Motions and Straw Polls

IEEE P802.3cg 10 Mbps Single-Pair Ethernet
Task Force

Spokane, WA USA, September 2018

Figure 1–1—IEEE 802.3 standard relationship to the ISO/IEC Open Systems Interconnection (OSI) reference model

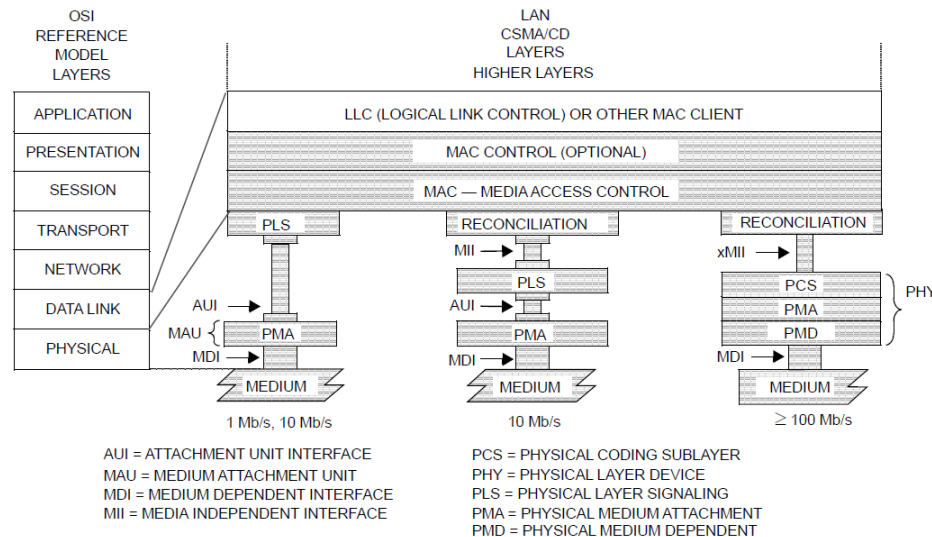
Move to disposition comment #304 as “Accept in Principle” with the following modifications to the draft.

In Clause 1.1.3 Architectural perspectives, update “Figure 1–1—IEEE 802.3 standard relationship to the ISO/IEC Open Systems Interconnection (OSI) reference model (shown below).

Change “100 Mb/s” at the bottom of the right column to “100 Mb/s, 10BASE-T1L, 10BASE-T1S”
